**City of Carson City
Agenda Report**

Subject Title: Action to approve a Tentative Subdivision Map application known as East Ridge Village from Western Engineering (property owner: Steve Ryckebosch, Eagletech Industrial Park LLC) to allow 115 lots for 113 Townhouse units on 17.65 acres, on property zoned Multi-Family Apartment, located at 7201 Highway 50 East. (TSM-08-043)

STAFF REPORT FOR THE PLANNING COMMISSION MEETING OF MAY 28, 2008

Proposed Site Plan for Eagle Ridge Village

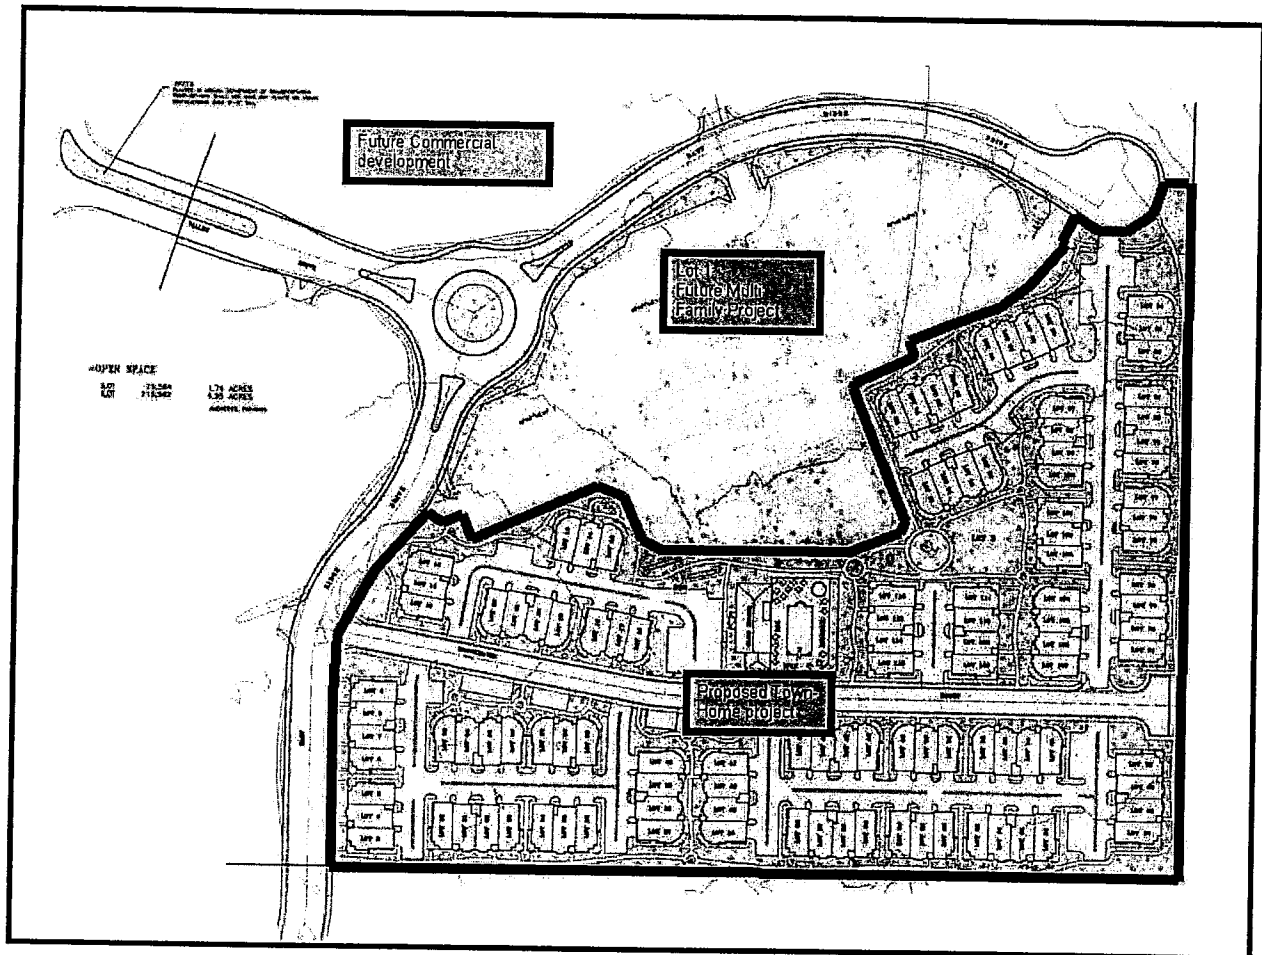
2. The applicant shall provide for and maintain two means of ingress/egress prior to construction. The map does not presently demonstrate the means or methods that will be used to connect East Ridge Drive to Flint Drive; this must be addressed before the final map.

The applicant shall provide for and maintain two means of ingress/egress prior to construction. The map does not presently demonstrate the means or methods that will be used to connect East Ridge Drive to Flint Drive; this must be addressed before the final map.
